# Oberon Renewable Energy Project

## PUBLIC SCOPING REPORT

**August 2021**

## Land Use Plan Conformance

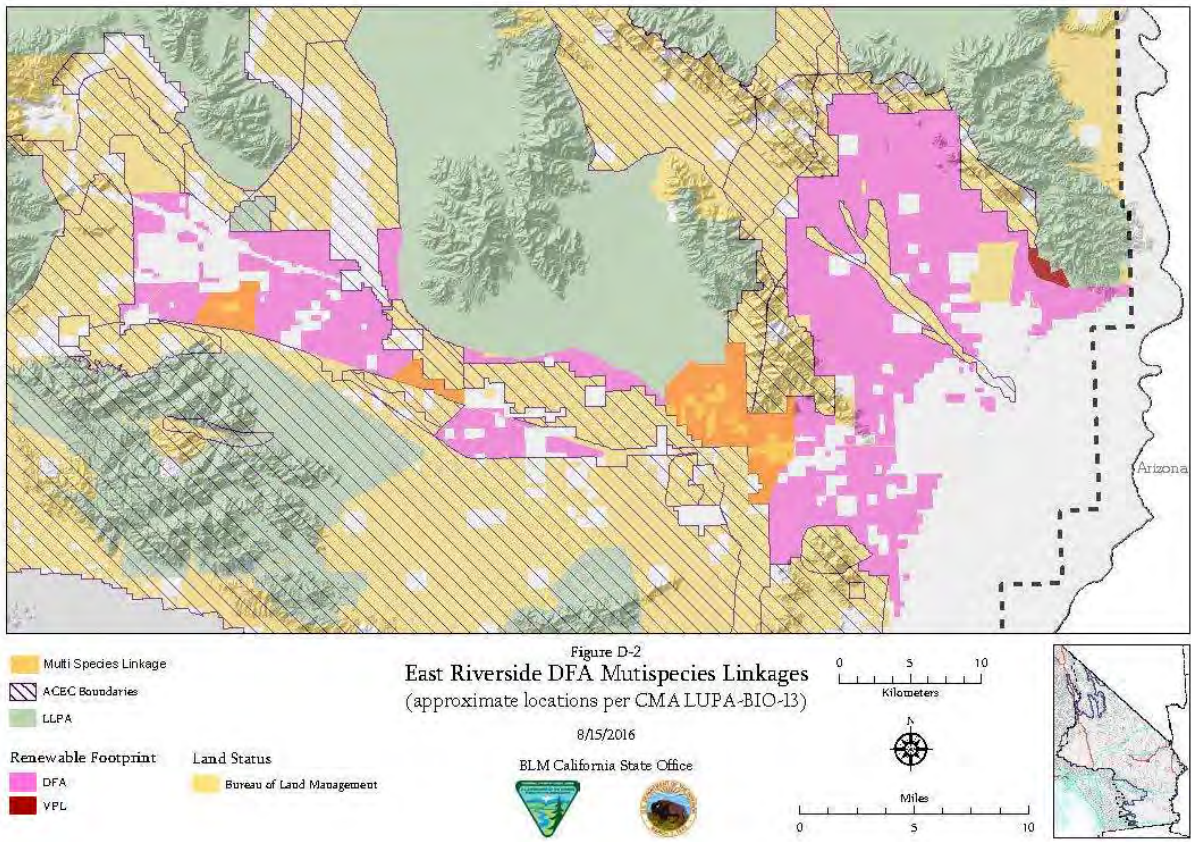
- The proposed project is located within a Development Focus Area
- Proposed project does not avoid all microphyll woodland or buffers as the DRECP prescribes

DRECP databasin map of microphyll woodland showing washes flowing downslope and northward from the Chuckwalla Mountains, through the proposed Oberon project site.

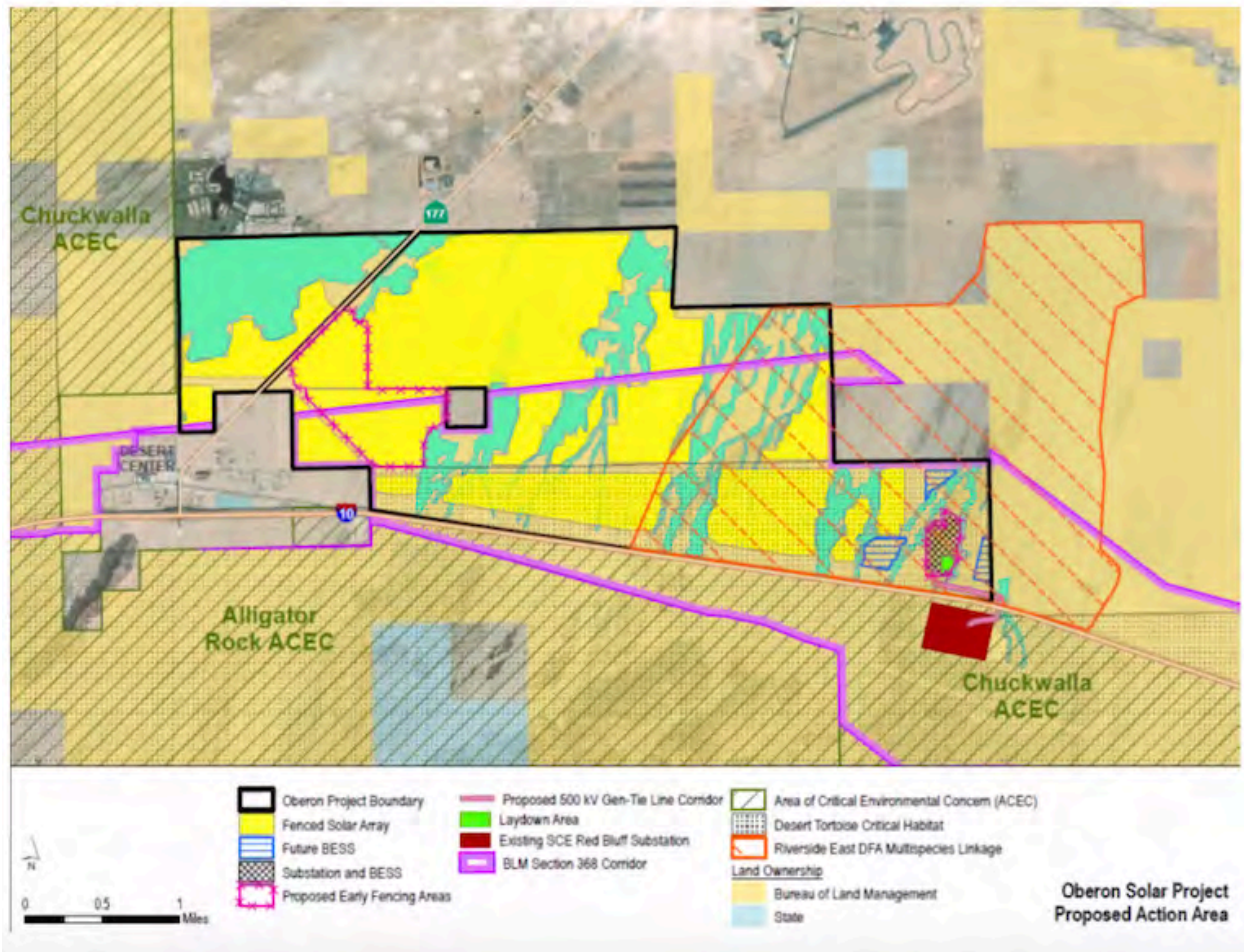
A discussion of how connectivity of wash plant communities needs to be included, because the solar field would block flow of flood waters in washes, potentially cutting off water-dependent microphyll woodland and killing patches on the other side of the proposed solar fields. This area receives monsoonal summer thunderstorms that are at times heavy, with flash floods flowing down washes into basin playas. Analysis of stormwater runoff needs to be undertaken related to the connectivity of microphyll habitats in ephemeral washes.

Map shown at the BLM Zoom scoping meeting on April 13, showing proposed solar fields cutting off wash flow from connecting washes coming off the Chuckwalla Mountains to the south—overlapping and even preferring tortoise Critical Habitat and multispecies linkage.

## Land Use Plan Conformance

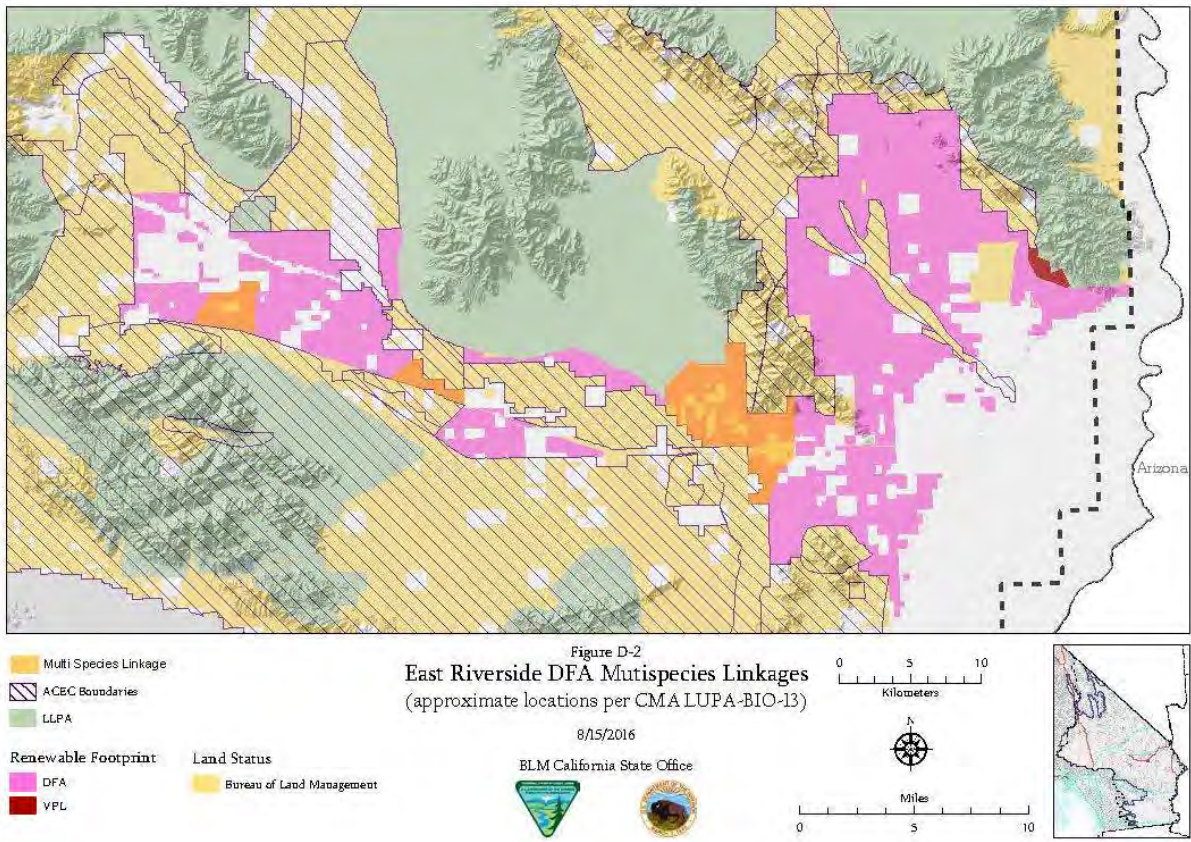
- The proposed project is located within a Development Focus Area
- Proposed project does not avoid all microphyll woodland or buffers as the DRECP prescribes

DRECP databasin map of microphyll woodland showing washes flowing downslope and northward from the Chuckwalla Mountains, through the proposed Oberon project site.

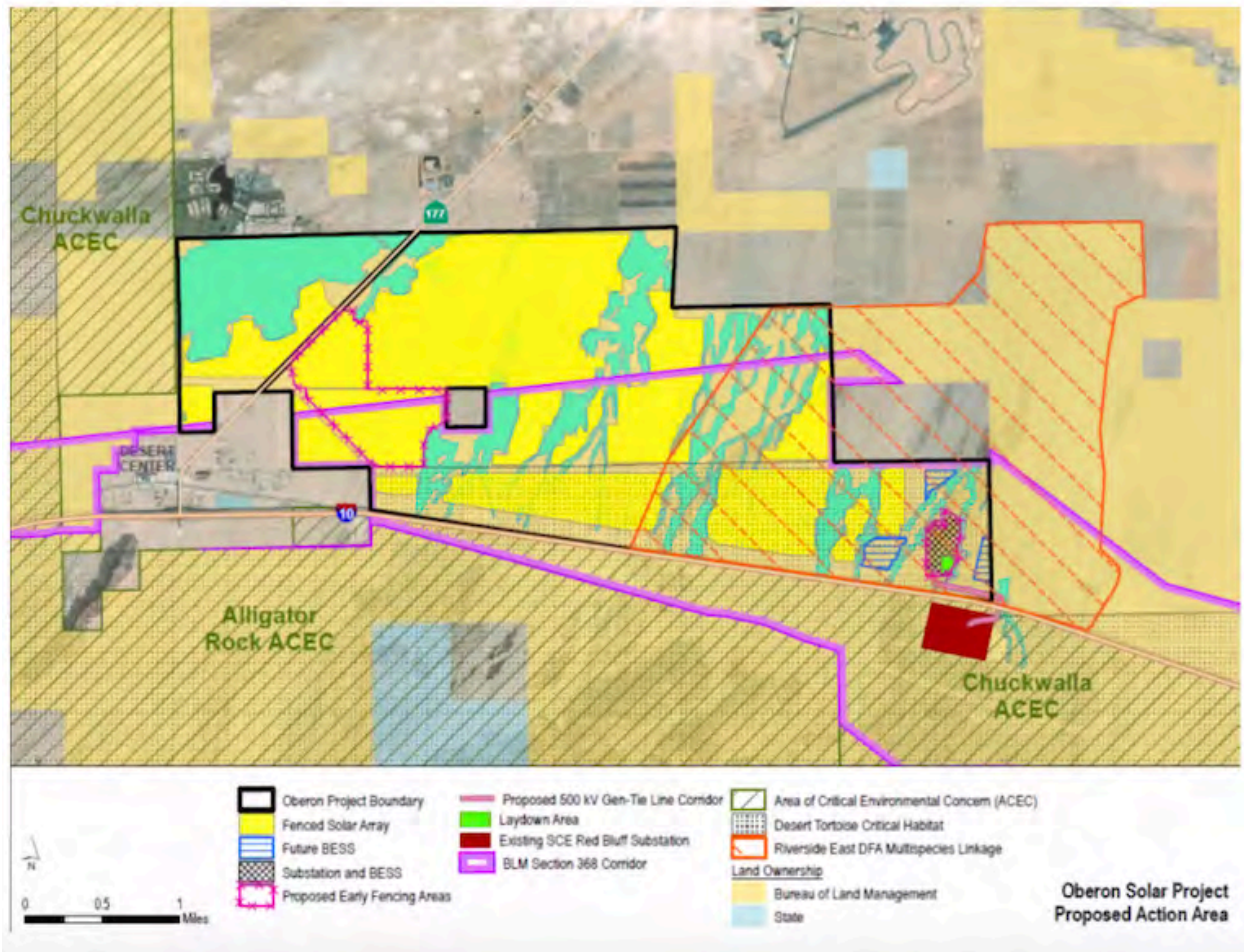
A discussion of how connectivity of wash plant communities needs to be included, because the solar field would block flow of flood waters in washes, potentially cutting off water-dependent microphyll woodland and killing patches on the other side of the proposed solar fields. This area receives monsoonal summer thunderstorms that are at times heavy, with flash floods flowing down washes into basin playas. Analysis of stormwater runoff needs to be undertaken related to the connectivity of microphyll habitats in ephemeral washes.

Map shown at the BLM Zoom scoping meeting on April 13, showing proposed solar fields cutting off wash flow from connecting washes coming off the Chuckwalla Mountains to the south—overlapping and even preferring tortoise Critical Habitat and multispecies linkage.
